# Staff Report

Infill Housing Design Review Committee

File Number: 9-C-24-IH

**Location:** 2422 Seymour Ave. **Parcel ID** 70 P B 02701  
**Zoning:** RN-2 (Single-Family Residential Neighborhood)  
**District:** Edgewood Park Infill Housing Overlay District

**SITE PLAN**  
not to scale

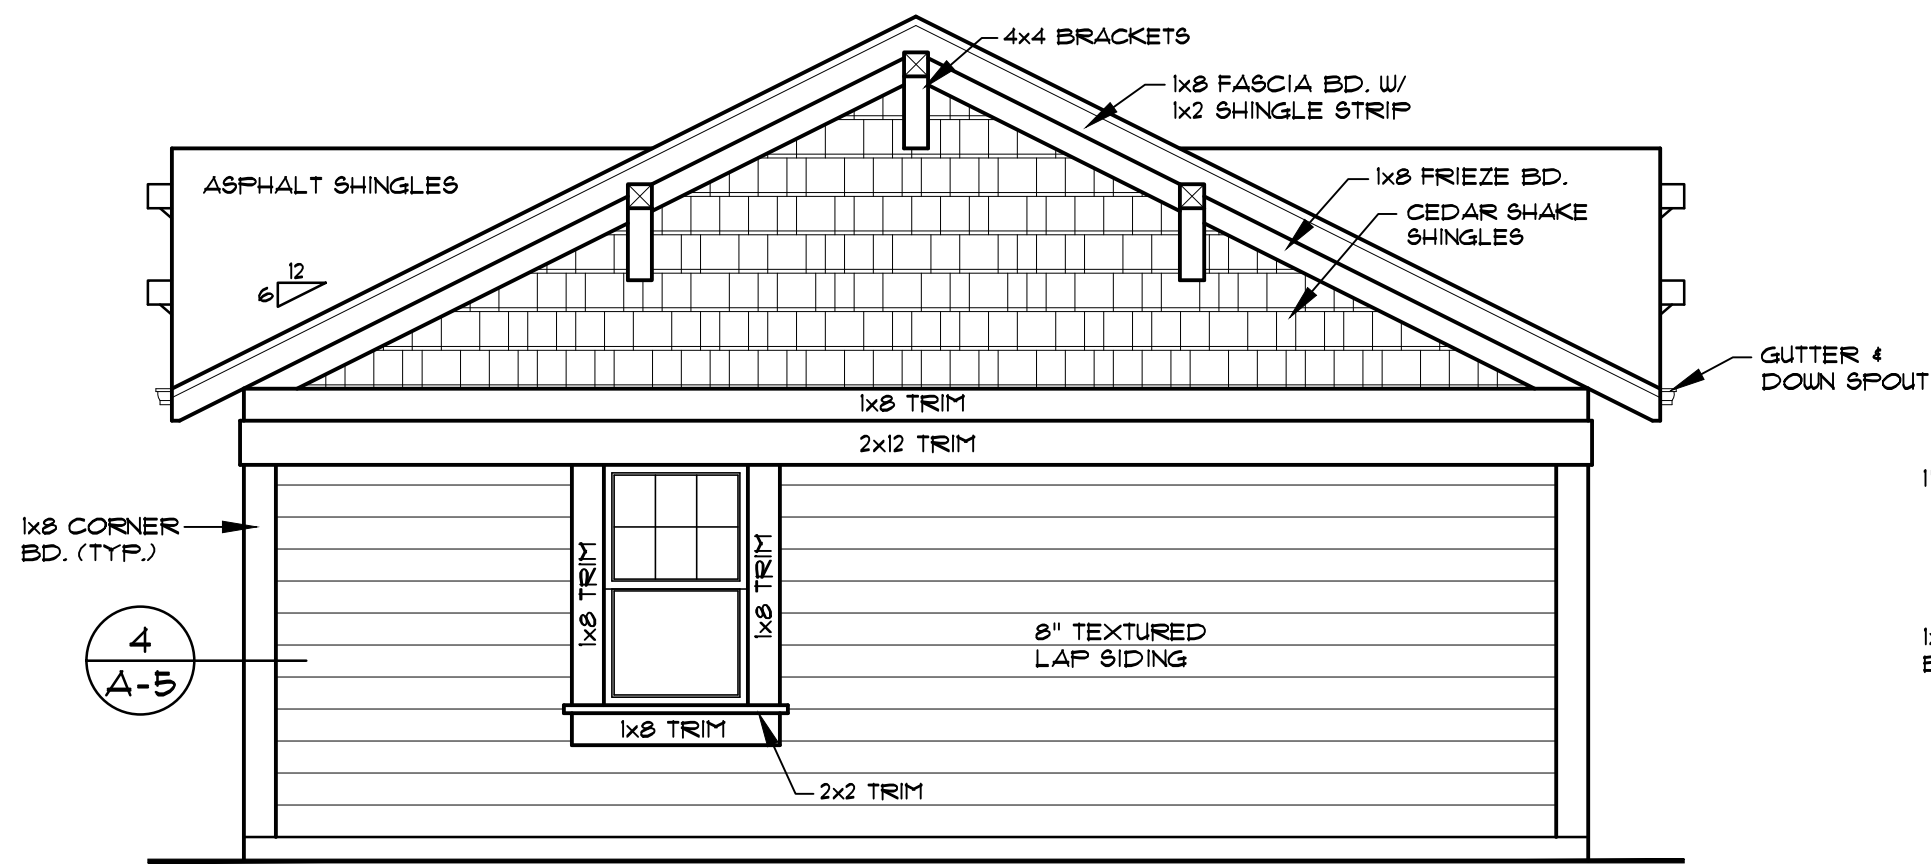
1. The house is proposed to be set approximately 46'-7" from the east side property line. Due to the flag lot, the house will be set behind 2418 Seymour Ave and face the side street, Derieux Dr. The house will be set well behind the existing blockface on Derieux Drive, as it's set behind the rear yard of 2426 Seymour Ave. Based on the setback requirements and the unique nature of the property, the proposed setbacks are sufficient. Due to the location and layout of the property, a walkaway to the street would not be possible.

3. The proposed parking is also complicated by the shape of the lot. Access off Seymour Ave is required, but the gravel parking area should be reduced in size to be limited to one lane adjacent to the house and eliminate the section of gravel parking area in front of the house. If a turnaround is needed, the house could be moved up towards the east property line and a turnaround could be located behind the house. The final site plan should meet City Engineering standards.

8. Overall, the asphalt shingle roofing, horizontal lap siding, and gable field shingles meet the design guidelines for materials.
9. The final site plan should incorporate one native or naturalized shade tree in the front and rear yards.

Staff recommends approval of Certificate 9-C-24-IH, subject to the following conditions: 1) site plan to be revised to avoid front yard parking; 2) final site plan to meet City Engineering standards; 3) front porch piers to be revised to be clad in brick veneer or stucco; 4) final site plan to include one tree in both the front and the rear yards.

1 FRONT ELEVATION  
A-4 1/4" = 1'-0"

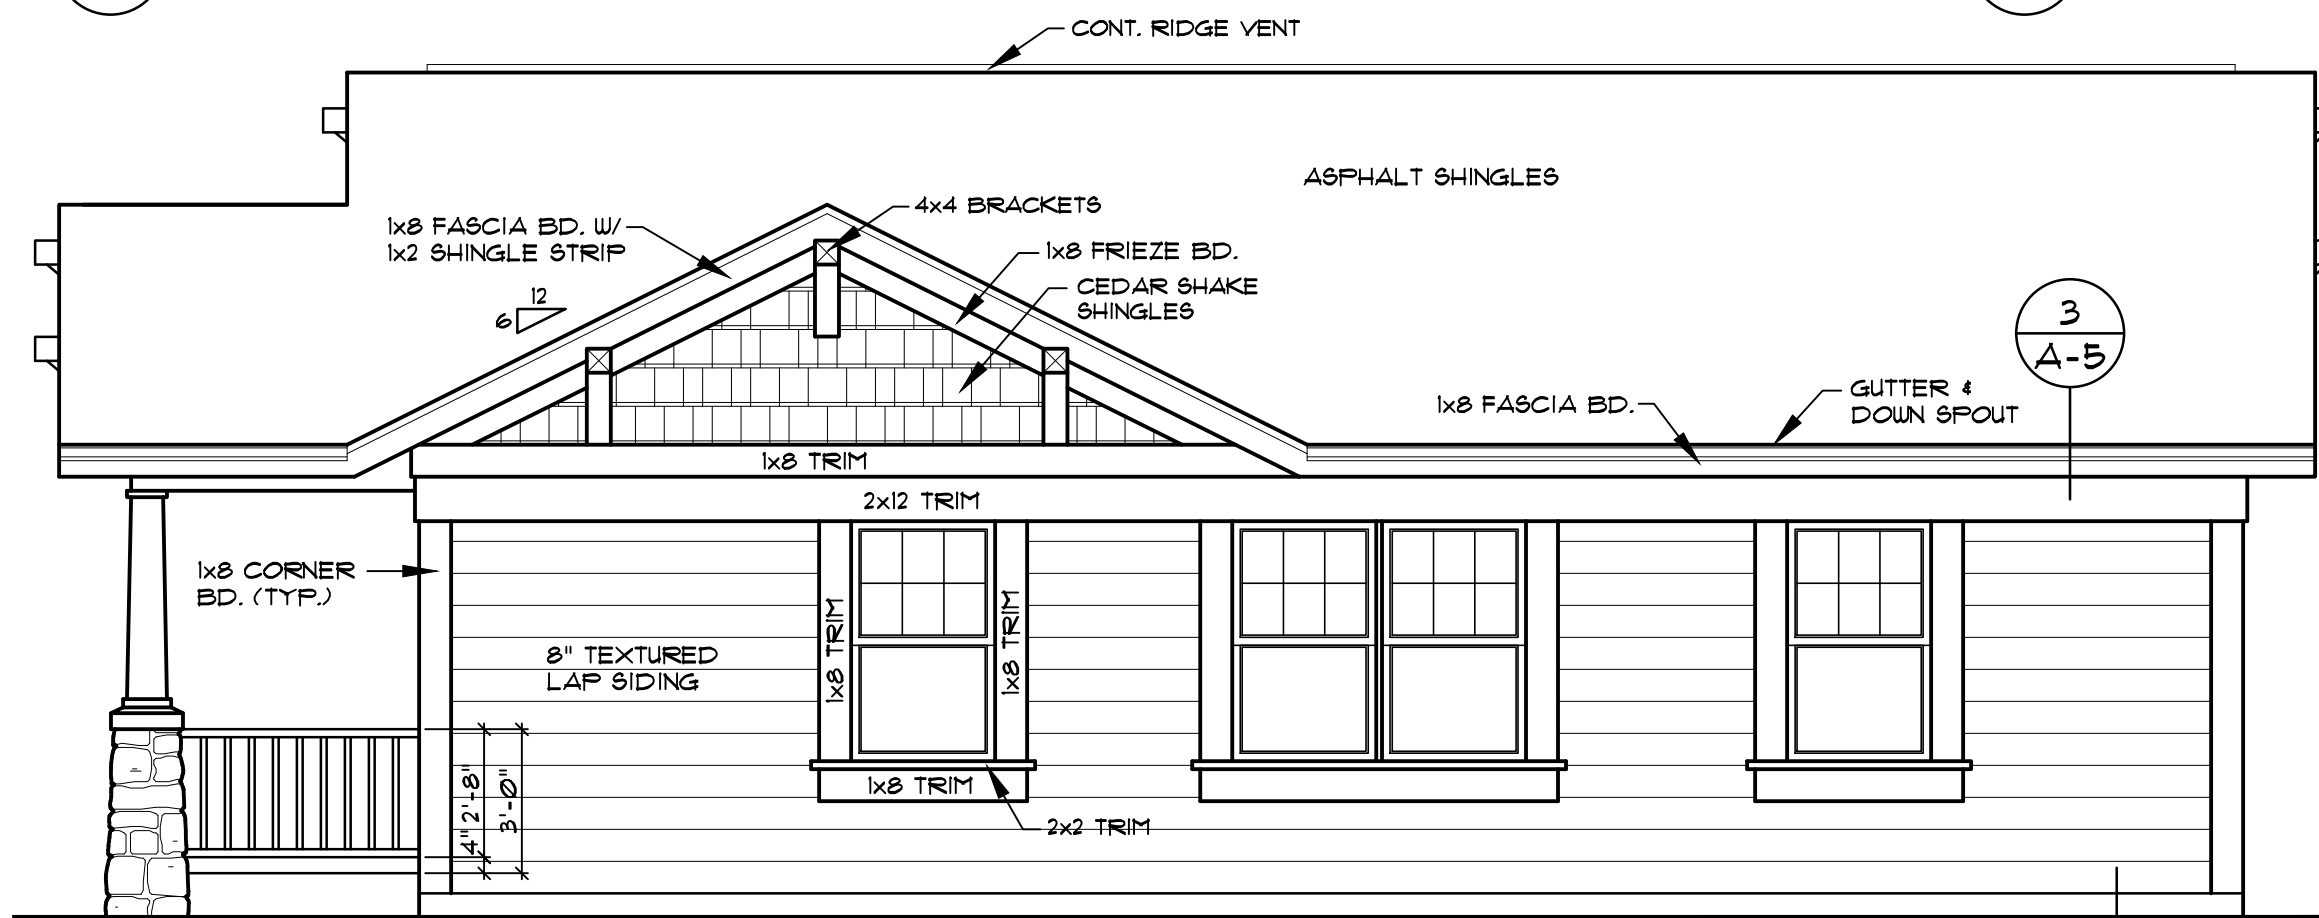
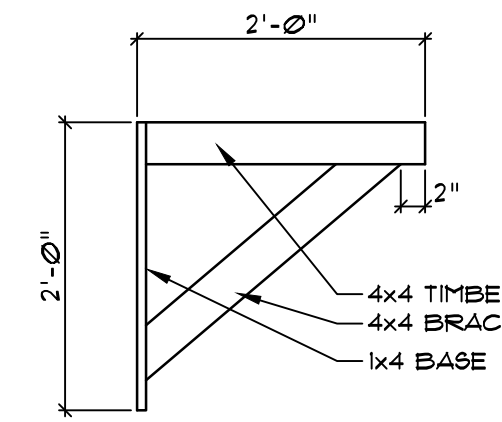
4. The façade is similar in scale and width to other houses along the street and in the broader context. Drawings indicate a slab foundation; the surrounding houses also have relatively low foundations.

5. The house incorporates a 6' deep, front-gable roof porch on the right half of the façade. The porch incorporates Craftsman-style details which contribute to the overall design, including triangular brackets in the gable field and tapered posts on piers. The design guidelines discourage stone veneer, which typically lacks precedent in Knoxville's historic neighborhoods; the piers could be clad in brick veneer or stucco.
